**STAFF REPORT - TYPE III
FINDINGS AND RECOMMENDATIONS**

FILE NUMBER: DR-E 09-26000230

PROPOSAL: Design Review for a 42-Bed Adult Care Facility
(Linden Care Manor)

Project: Linden Care Manor

TRASH ENCL. SECTION
SCALE: 3/4" = 1'-0"

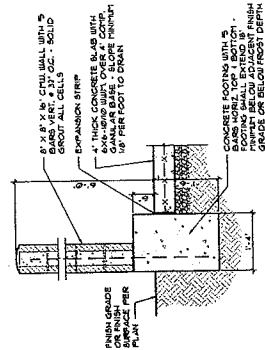
After reviewing the application and drawings, it appears that the garbage and recycling enclosure is undersized for the square footage and type of development. The enclosure is designed to accommodate two 2-yard garbage dumpsters, two 95-gallon recycling roll carts and one 35-gallon glass roll cart. This level of service is insufficient. The Recycling and Garbage Service Planning Matrix indicates that such a use would need a minimum of 14.4 yards of garbage service weekly, plus a 6-yard recycling cage and at least one glass roll cart.

1. Widen enclosure to accommodate one forward-facing 6-yard garbage container, one 4-6 yard recycling cage, plus one glass only recycling roll cart.
2. Move, expand, and rotate orientation of enclosure due East of planned location to allow for direct truck access to enable direct front stab servicing of the 6-yard garbage container. The 4-6 yard recycling cage does not need to face the front of the enclosure and can be oriented perpendicular to the 6 yard garbage container (parallel to the side wall of the enclosure).

To minimize width of the enclosure, staff recommends that the enclosure doors be mounted flush with the side walls of the enclosure, as opposed to having the short enclosure walls on the front face of the enclosure. Inside dimensions of the enclosure should be approximately 18.5 feet wide by 9.6 feet deep.

7. Move, expand, and rotate orientation of garbage enclosure due east of planned location to allow for direct truck access to enable direct front stab servicing of the 6-yard garbage container. The 4-6 yard recycling cage does not need to face the front of the enclosure and can be oriented perpendicular to the 6-yard garbage container (parallel to the side wall of the enclosure).

8. To minimize width of the garbage enclosure, staff recommends that the enclosure doors be mounted flush with the side walls of the enclosure, as opposed to having the short enclosure walls on the front face of the enclosure. Inside dimensions of the enclosure should be approximately 18.5 feet wide by 9.6 feet deep.

PRELIMINARY PLAN OF
LINDEN CARE MANOR
PRELIMINARY STREET AND UTILITY PLAN

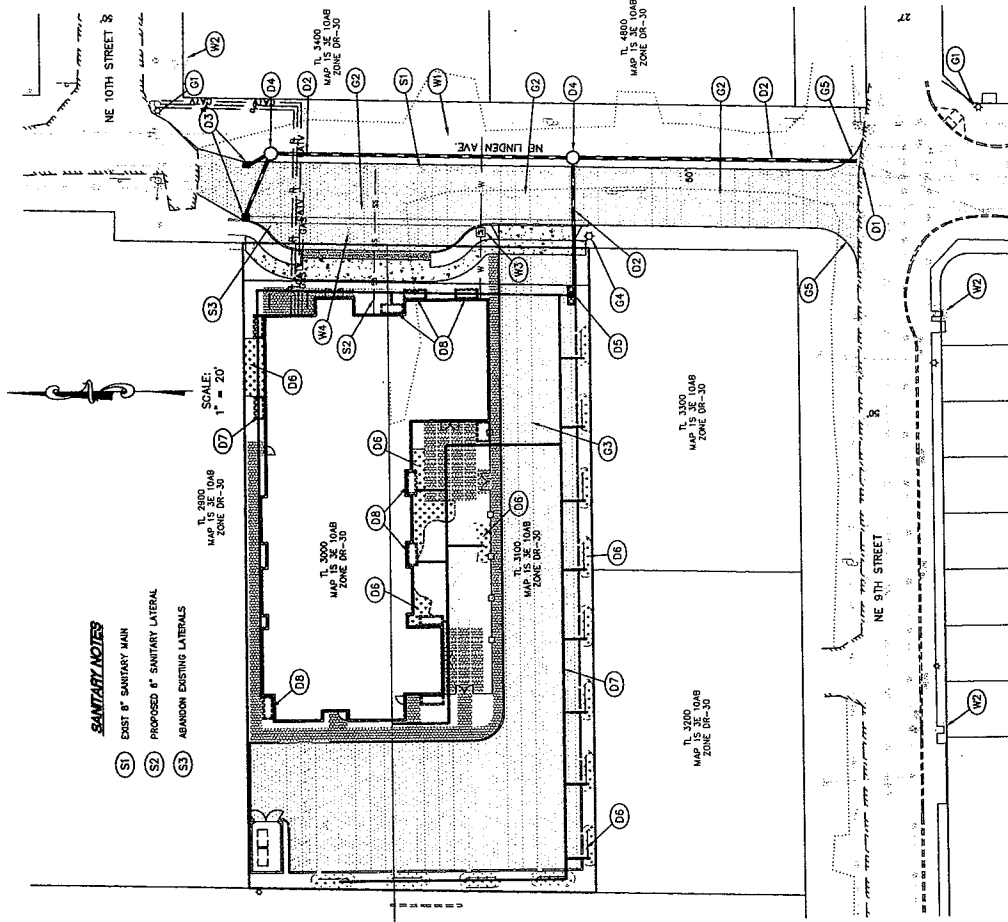
remain to serve the new use. Only one will be allowed; unused laterals shall be abandoned at the main. The plans show one new lateral; however, it is unclear if it will be connected to an existing tee or if it is a new tap. Clarify on construction plans.

The applicant will be responsible for extending a storm main along Linden Avenue from 9th Street to convey runoff from the development, as shown on the plans. City records (as-built drawings NE0287C and NE0320AH) indicate an existing 15-inch storm line on the north side of the existing manhole at Linden and 9th Street. Verify size/length of this pipe on the construction plans.

City records (as-built drawings NE0287C and NE0320AH) indicate an existing 15-inch storm line on the north side of the existing manhole at Linden and 9th Street. Verify existing/size/length of this pipe on the construction plans.

Records indicate an existing 5/8-inch meter on a 3/4-inch service, which does not meet current standards. This service will need to be abandoned and replaced with one adequate to serve the new development. The applicant has indicated the need for a 2-inch meter; this may be adjusted based on demand calculations to be submitted. City crews will perform the water taps at the applicant's expense.

12. Clarify existing and proposed wastewater lateral locations on the construction plans, and abandon any unused laterals at the main.

19. The existing substandard water service will need to be abandoned and replaced with one adequate to serve the new development.
20. Utility lines shall be relocated underground in accordance with Section A5.510 of the Development Code.
